6 June 2022

Director:
Department of Forestry, Fisheries and the Environment

RE: 84MW IZIDULI EMOYENI WIND ENERGY FACILITY (WEF): TERRESTRIAL AND AQUATIC SPECIALIST COMMENTS RELATED TO THE INCLUSION OF TERRESTRIAL AND AQUATIC RECOMMENDATIONS IN THE FINAL LAYOUT

Figure 2. Comparative sensitivity map of the turbine layout used to undertake the walkthrough surveys vs the final turbine layout (the findings of the walkthrough survey were used in micro-siting of the final turbine layout).

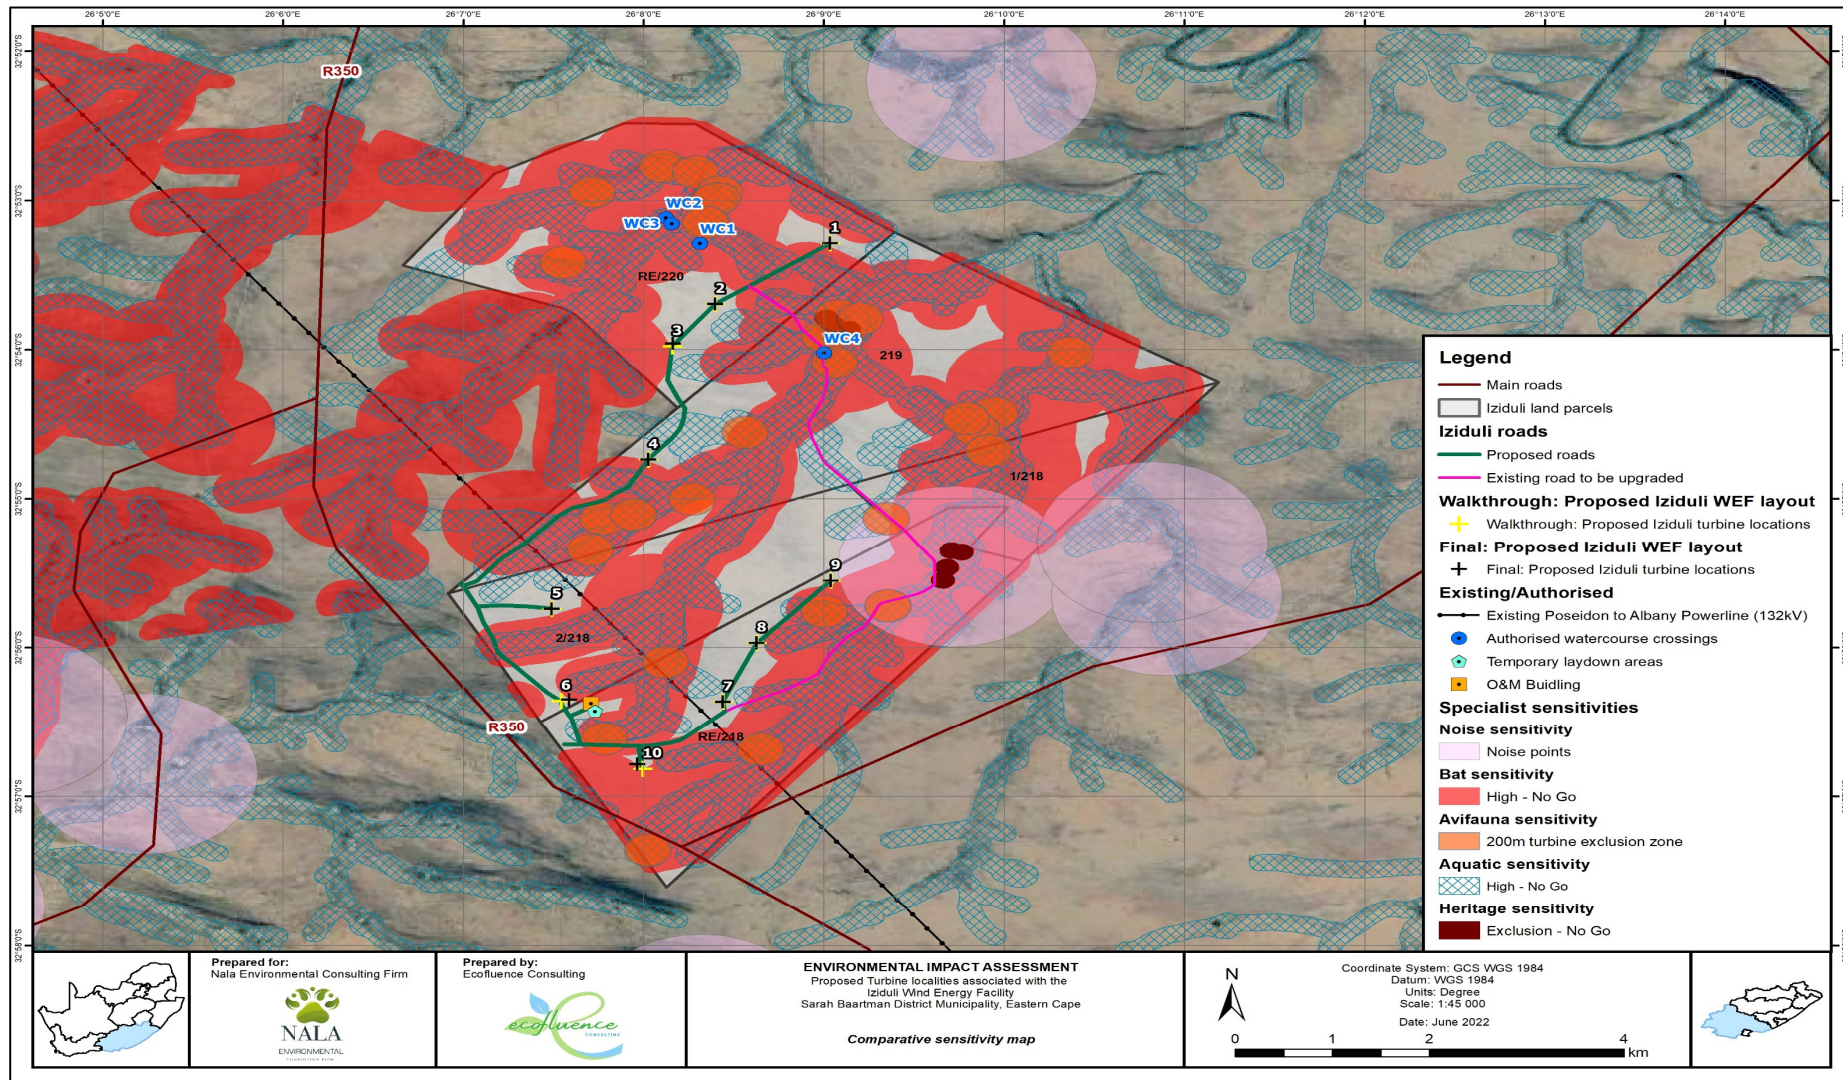
It is the team's view that the design of the final layout took their recommendations into consideration where practically feasible to do so, and where not in conflict with the recommendation of another specialist. Based on this approach, the team recommends the authorisation of the proposed layout on condition that the proposed recommendation are included in the EMPr and are implemented during all phases of the project, with the following specifications:
